Staff Report

From: Colin Cortes, AICP, CNU-A, Senior Planner

Meeting Date: September 26, 2019 (Prepared September 19, 2019)

Item: 1800 W. Hayes Street “Nellie Muir Elementary School” (CU 2019-05)

1 EXISTING CONDITIONS AND DEMOLITION PLAN - OVERALL
1" = 40'

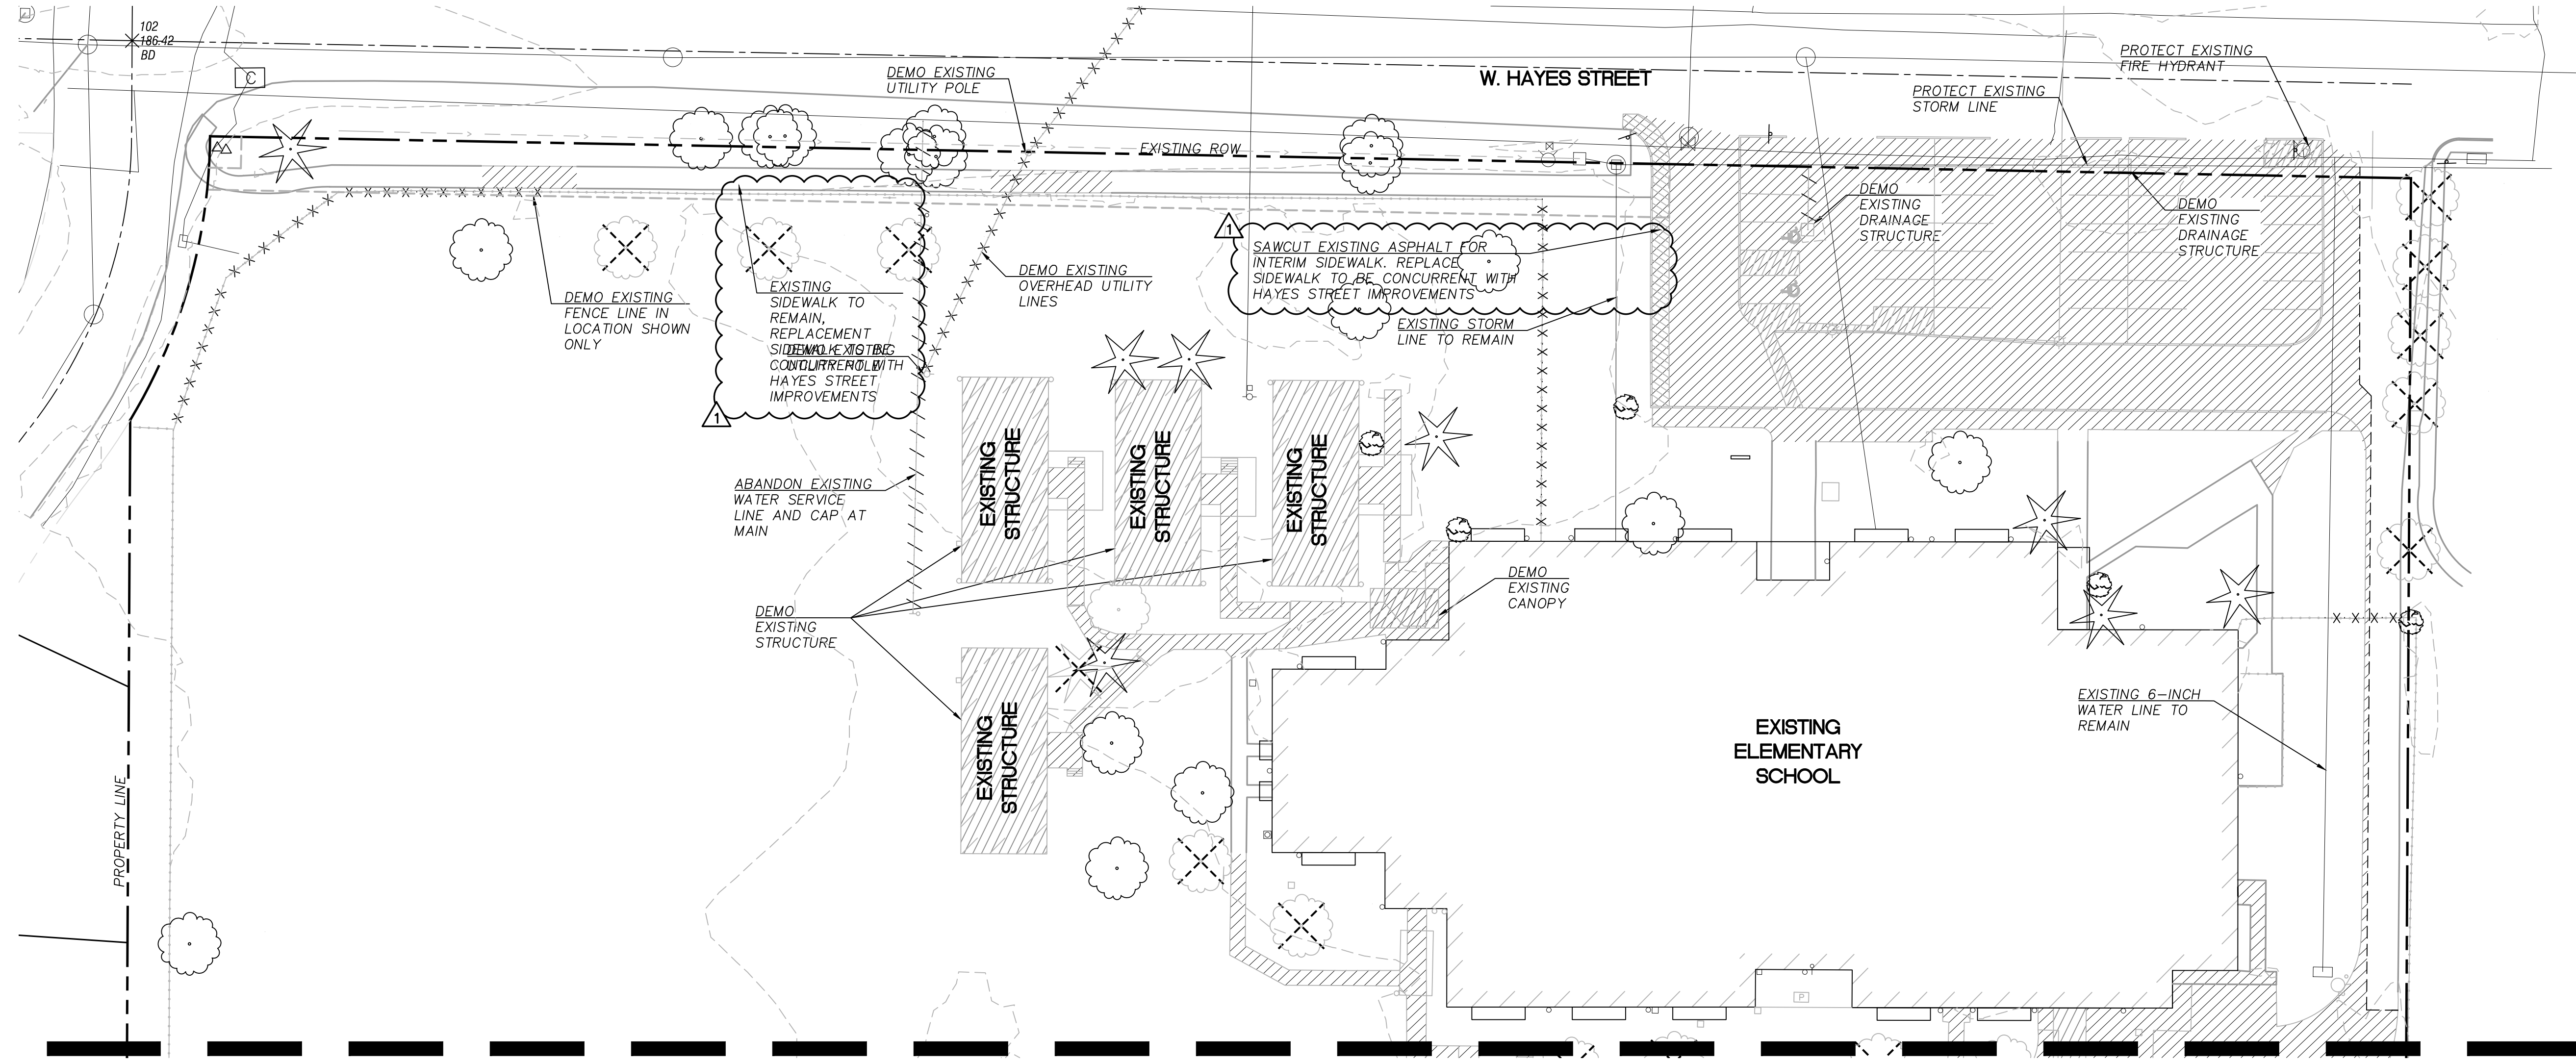
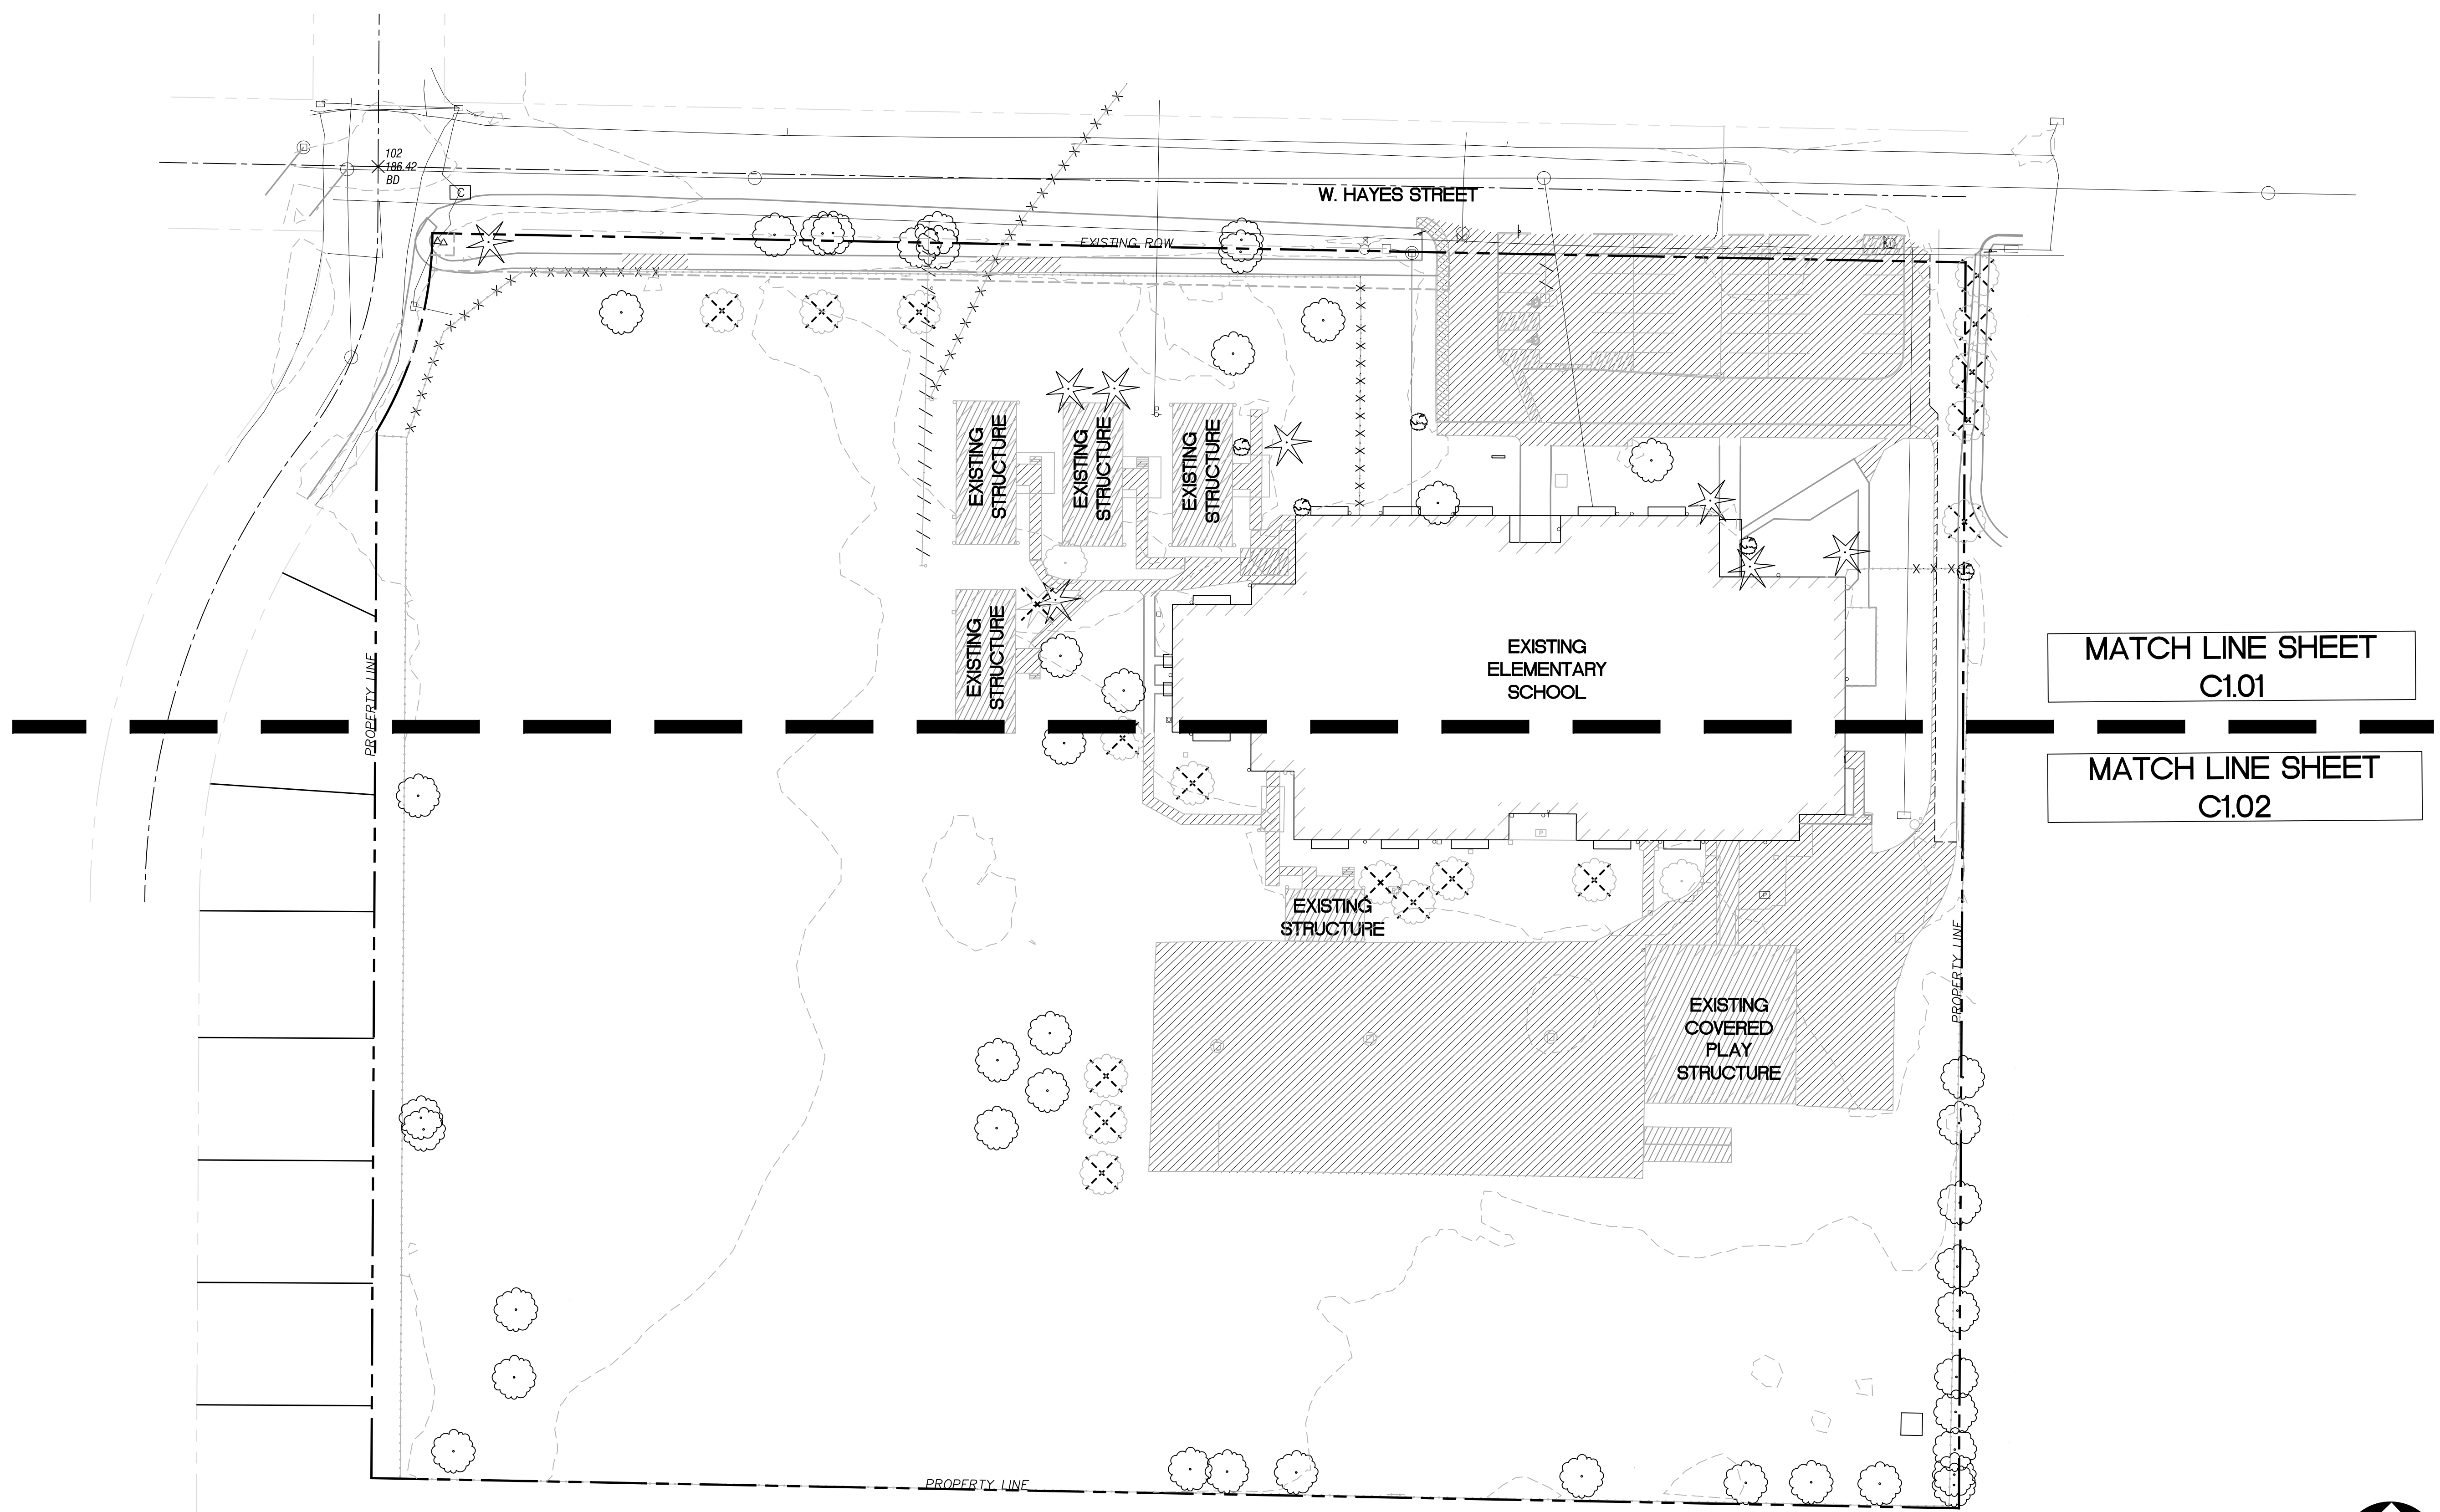
C8. Modular buildings / modulares: Consistent with the land use review plan set submitted August 23, 2019, Sheets C1.00 Existing Conditions and Demolition Plan and C2.00 Layout and Paving Plan Overall, the number of modular buildings shall go from four (4) to zero (0) and remain at zero. The removal of modular buildings is due by building permit final inspection. The City may later supersede this condition by taking action on a future land use application submittal as to allow one or more modular buildings.
